SUBJECT: PRELIMINARY SITE PLAN REVIEW (File Number SP 967) – Proposed Gaucho Brazilian Steakhouse, 3635 Rochester Road, West Side of Rochester between Troywood and Colebrook, Section 22, Currently Zoned B-3 (General Business) District

Preliminary Site Plan Review For City of Troy, Michigan

Applicant: Gaucho, LLC
Project Name: Gaucho SteakHouse
Plan Date: April 1, 2011
Location: 3635 Rochester Road
Zoning: B-3, General Business District and P-1, Parking District
Action Requested: Preliminary Site Plan Approval
Required Information: Deficiencies noted

A0.0

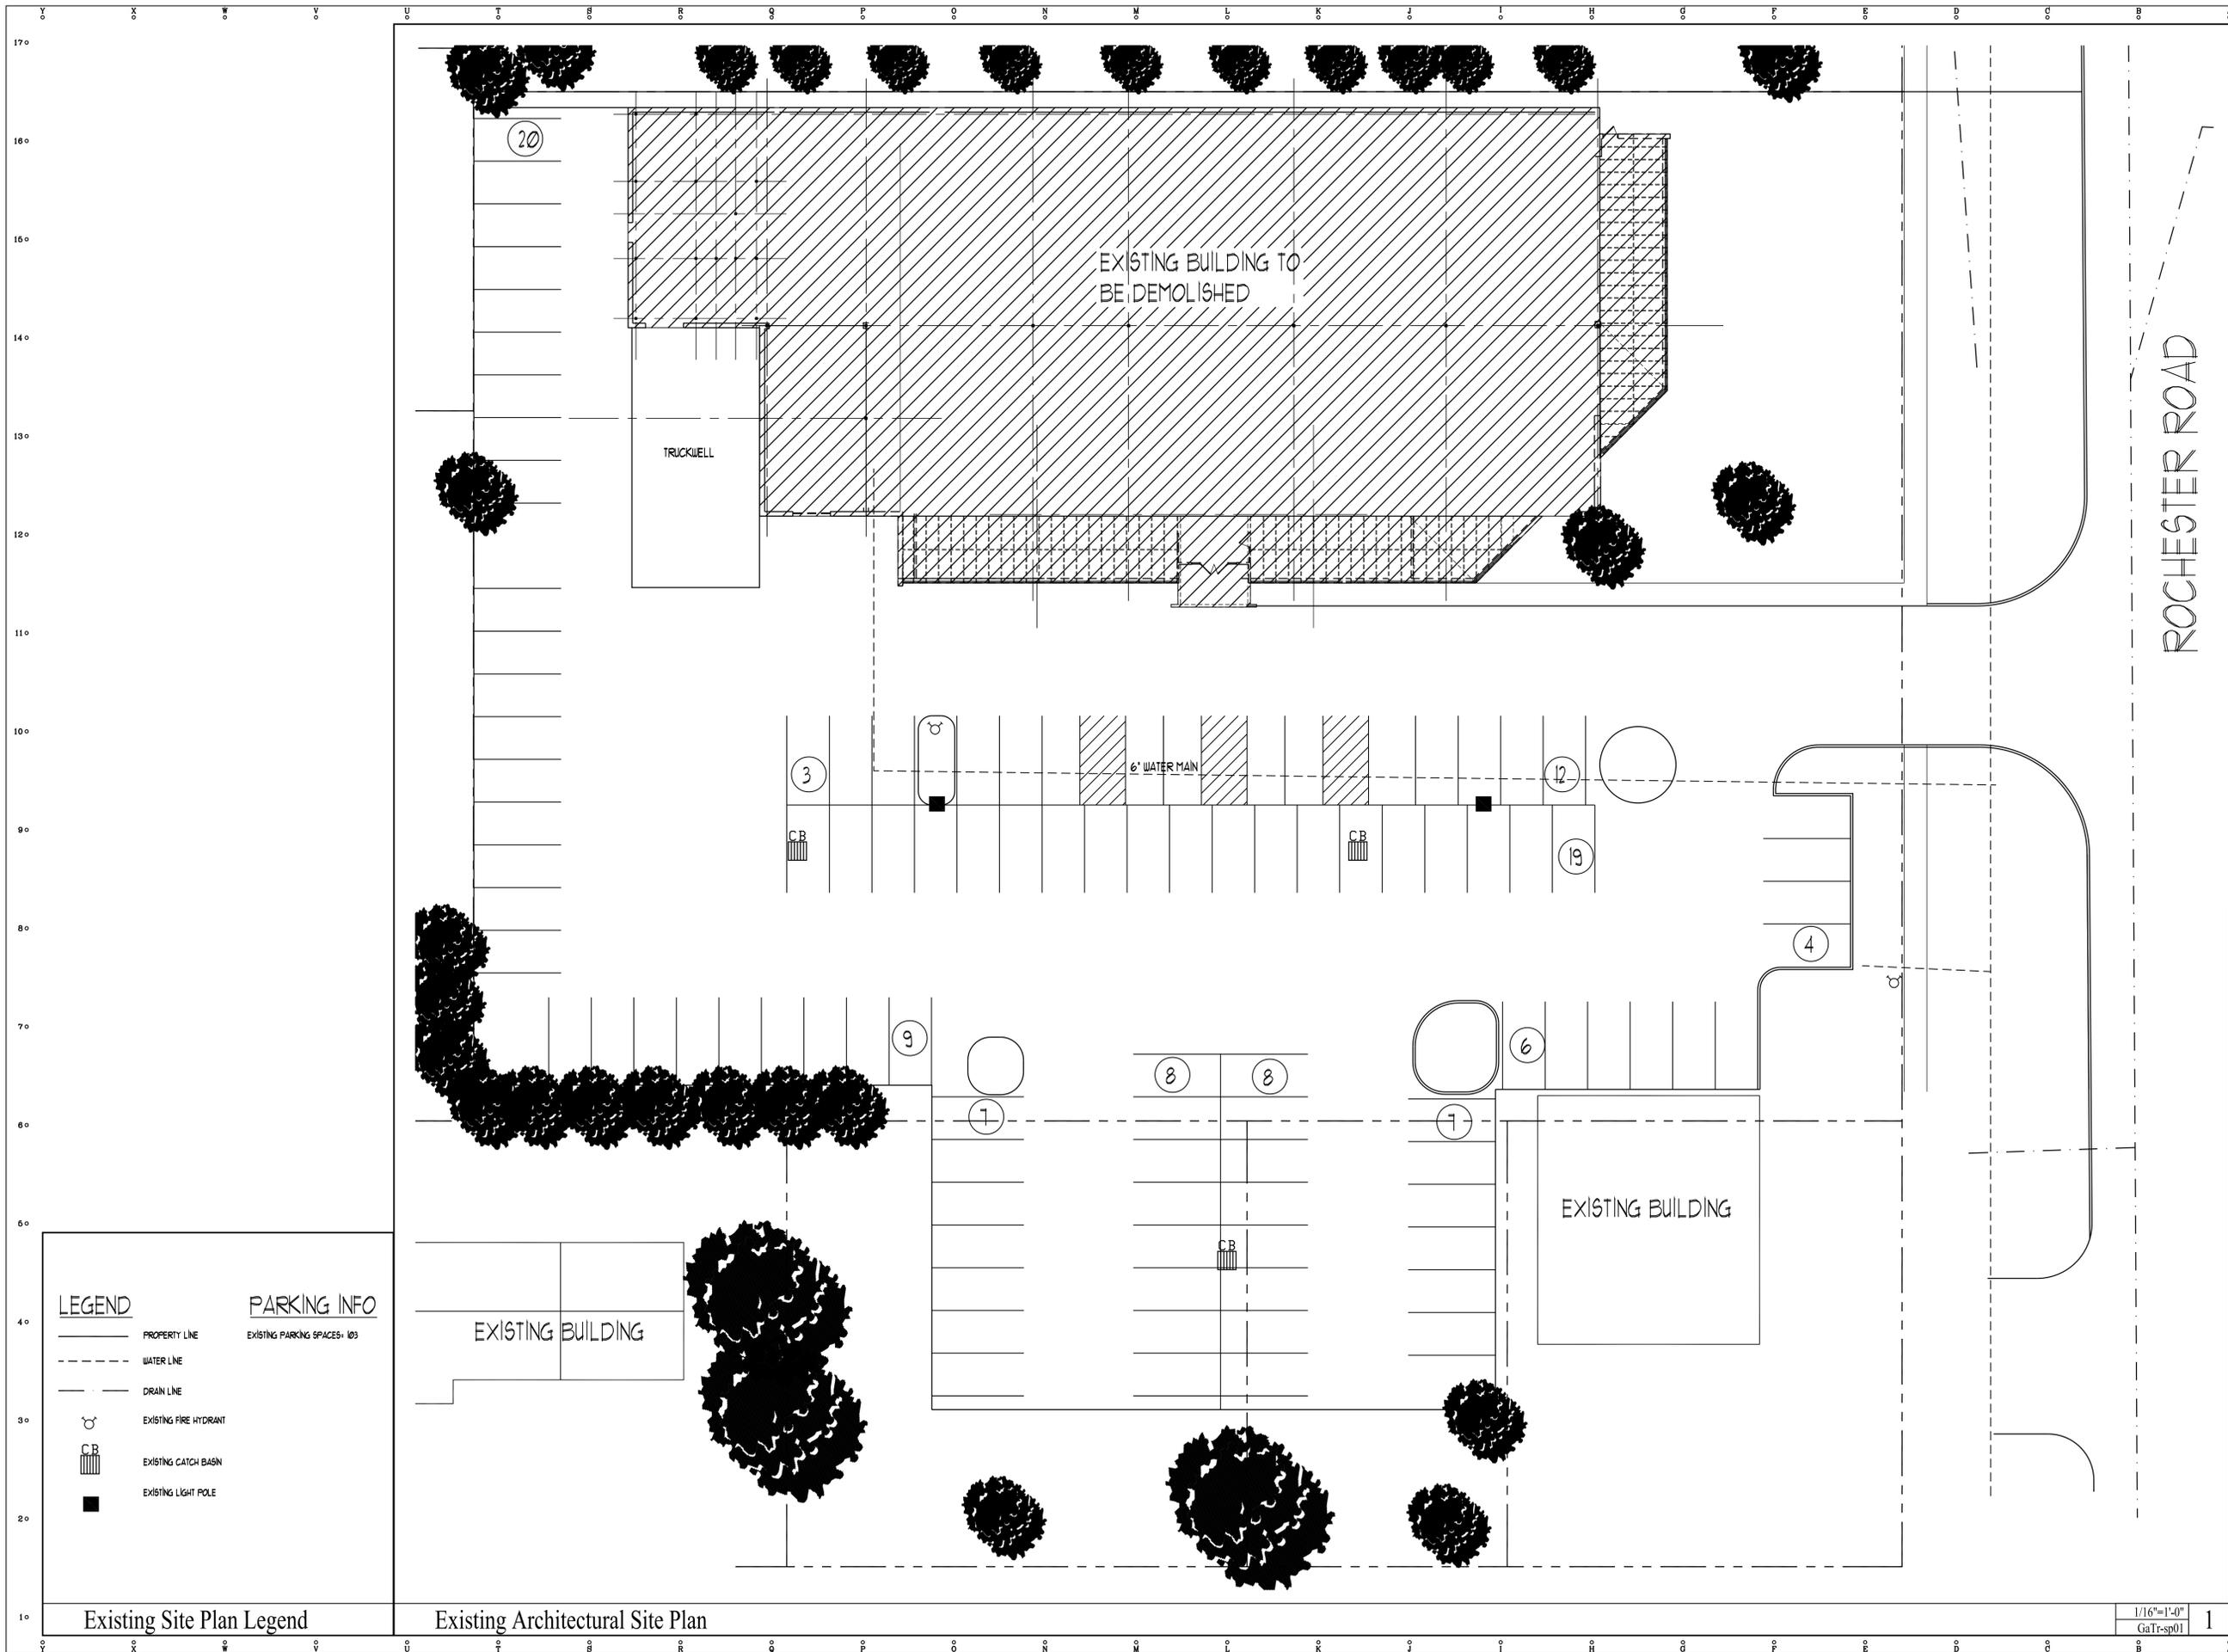
1. The present zoning classification of the subject property.
2. A location map (minimum scale of 1"=400') indicating the subject property and the zoning classifications and uses of abutting and adjacent properties, on 8-1/2 x 11 pages, shall be attached to the application. *The plan includes a location map inset on the cover sheet, but no information about adjacent zoning or uses has been provided.*

SP1.1

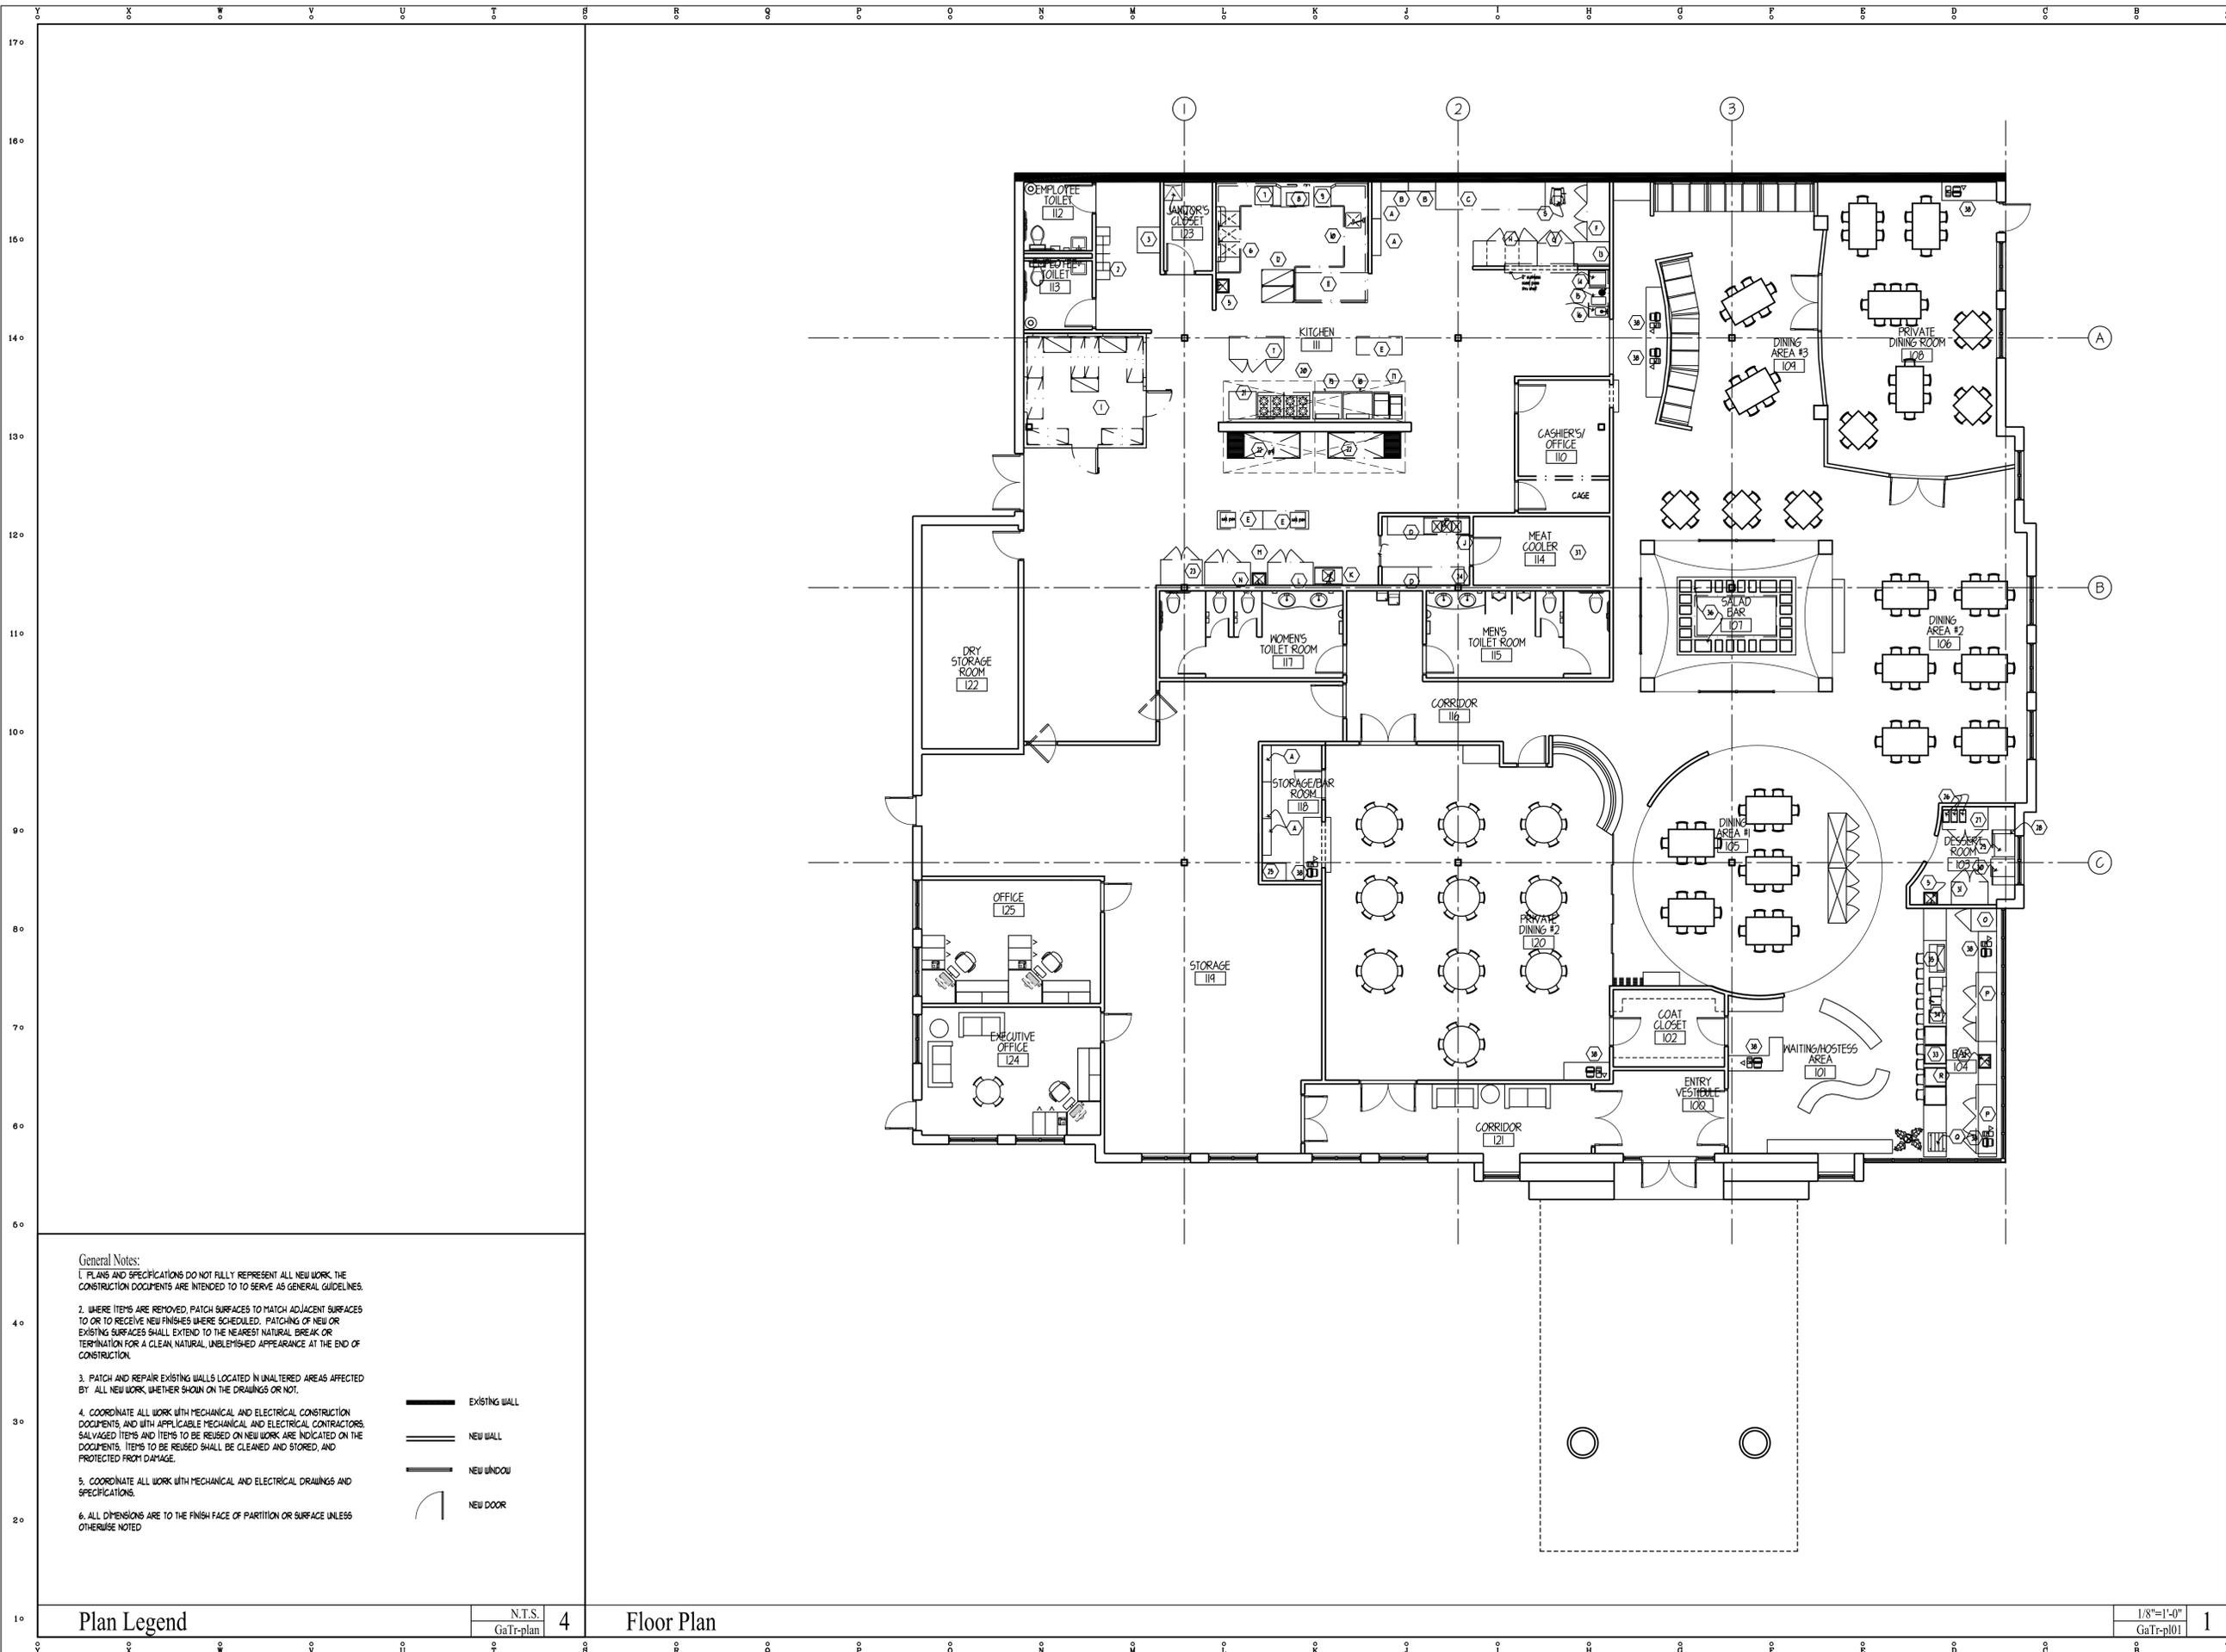
Items to be Addressed: Provide detailed dimensions of required and proposed setbacks.

The site plan shows 131 parking spaces, barrier free spaces are not clearly identified, though reserved area for van accessible spaces appears to be provided for at least 5 spaces near the entrance.

The applicant has provided 19 extra parking spaces. The proposed plan meets minimum parking requirements, but we object to the provision of such a large surplus of parking on the site. We recommend the applicant remove a portion of the proposed parking and provide no more than that required by Ordinance.

Items to be Addressed: Remove surplus parking and detail proposed barrier-free spaces.

The site plan provides limited landscaping information, but does not provide full details about the quantity, species, or details of proposed materials. The plan shows proposed tree location, but may also show existing tree locations. Many of the illustrated trees are not within what we believe to be the site boundary. We cannot fully determine if requirements are being met in accordance to the City of Troy Landscape Design and Tree Preservation Standards.

The site plan shows extensive existing trees off site and on site. It is not clear what trees are proposed or existing, and which are intended to satisfy greenbelt or parking or general landscaping requirements.

It does appear that an extensive tree planting program is contemplated for the site, given the tree stamps on the drawings, however we cannot make any formal determination in this regard until detailed information is provided.

A ten (10) foot wide greenbelt has been provided along the public street frontages. No formal information about required trees has been provided, although the site plan does show that trees are proposed.

3. All drawings are to have a northpoint and the scale of the drawing is to be indicated. *No northpoint is provided.*
4. All lot and property lines. *The property boundary is somewhat unclear. We understand that the site is currently being surveyed. As it stands it appears the site boundary goes through the adjacent building to the south.*

5. Existing and future right-of-way of adjacent streets, including centerlines and Section Lines where applicable. *The Engineering Department comments that the existing road conditions shown on the site plan do not reflect the recent improvements to Rochester Road.*

6. Location of all sidewalks, on and adjacent to the site, as required by the Zoning Ordinance and the Sidewalk Ordinance. *Sidewalks are shown, but are not clearly labeled or dimensioned.*

7. Indication of the means by which storm water detention will be provided. *The Engineering Department commented that the site currently utilizes parking lot detention that must be retained. This must be indicated on the site plan.*

8. Setbacks and required yards. *These are not shown on the site plan.*
9. Parking areas, access drives, loading and unloading areas, and trash receptacles. *No loading or unloading, nor any trash areas are shown. We expect that a dumpster will be necessary. A dumpster pad and enclosure must be provided and shown on the plan and detailed with elevations and proposed materials.*

10. Greenbelts, landscape areas and other open space areas; and screening walls. *Existing walls are not identified on the plan, nor are existing landscape materials or the required greenbelt and required greenbelt materials.*

3. Required parking and statement of parking provided.
 4. Required landscape and open space area and statement of area provided.*The gross and net area of the site are not provided.*

12. A Landscape Plan prepared in conformance with the City of Troy's Landscape Design Standards. *The site plan application does include basic information about landscaping (area, etc.) but does not include any information about landscape calculations, proposed plant material species, plant details and dimensions, or proposed quantities.*
